Docket Item #'s 12 & 13
BAR CASE #2006-0261/262

BAR Meeting
December 6, 2006

ISSUE: Addition and alterations and Waiver of the rooftop HVAC screening requirement

LOCATION: 511 Queen Street

Figure 1 - North elevation

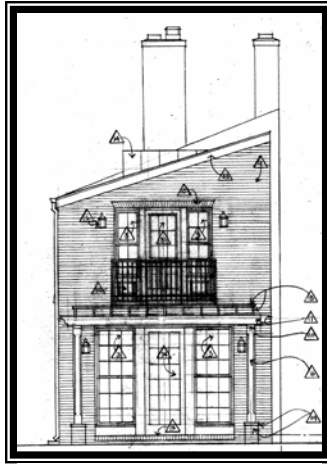
In the opinion of Staff the design of the proposed addition is appropriate. The design follows the historic lines of the existing house, essentially replicating the flounder form. The proposed materials for the addition are traditional building materials and meet the recommendations of the *Design Guidelines*. Further, the public perception of a freestanding flounder house will not be altered because the proposed additions are at the rear of the property and not readily visible from a public right-of-way. Based upon the Board's previous approvals of the addition, Staff again recommends approval.

Figure 2 - East elevation

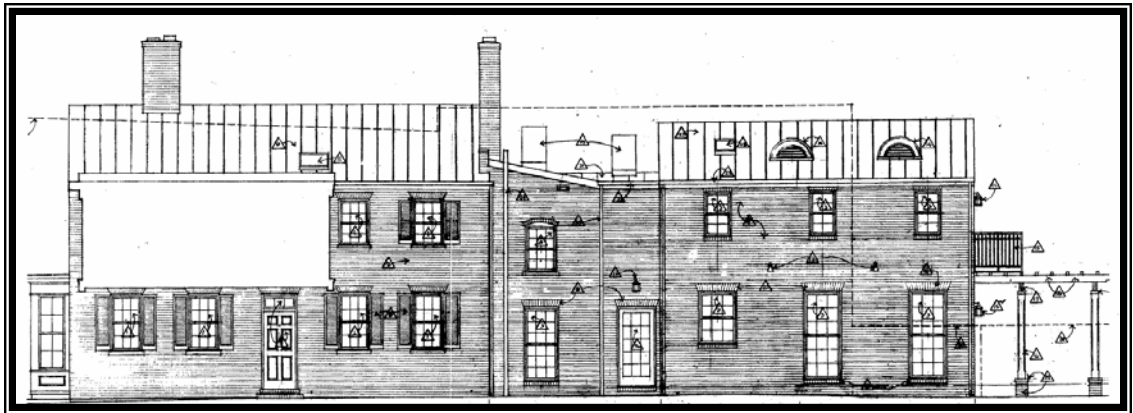
At the proposed rear addition on the east side there will two six-over-six windows on the first level and a single four-over-four window on the second level. At the rear of the addition there will be a new multi-light door flanked by six-over-six windows on the first level with a similar configuration on the second level. A metal railing and balcony will be installed across the door and windows on the second level. An eyebrow dormer for ventilation will be installed on the roof. A new wood arbor is proposed at the north end of the addition to replace an existing arbor.

The new raised second story section will also have two four-over-four windows on the second level and a six-over-six windows on the first level. A new skylight is proposed for the roof along with an eyebrow dormer for ventilation.

Figure 3 - West elevation

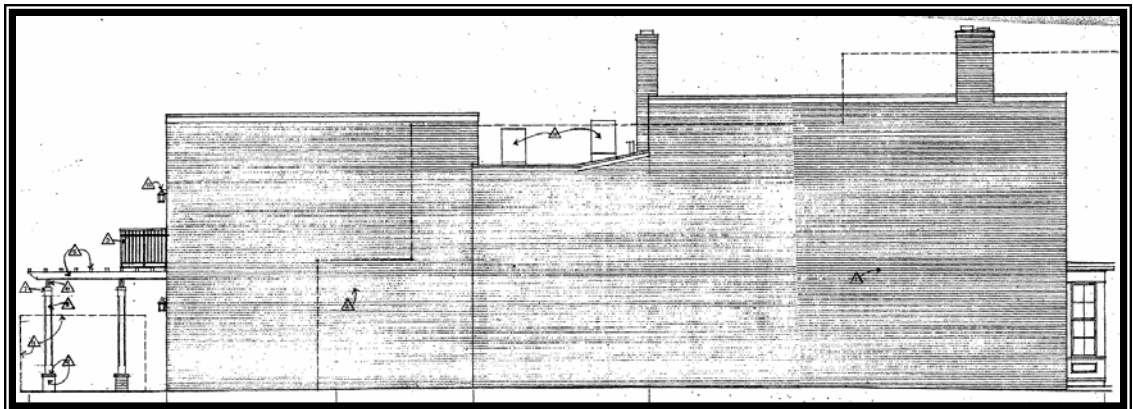
There is no fenestration on the west side of the addition.
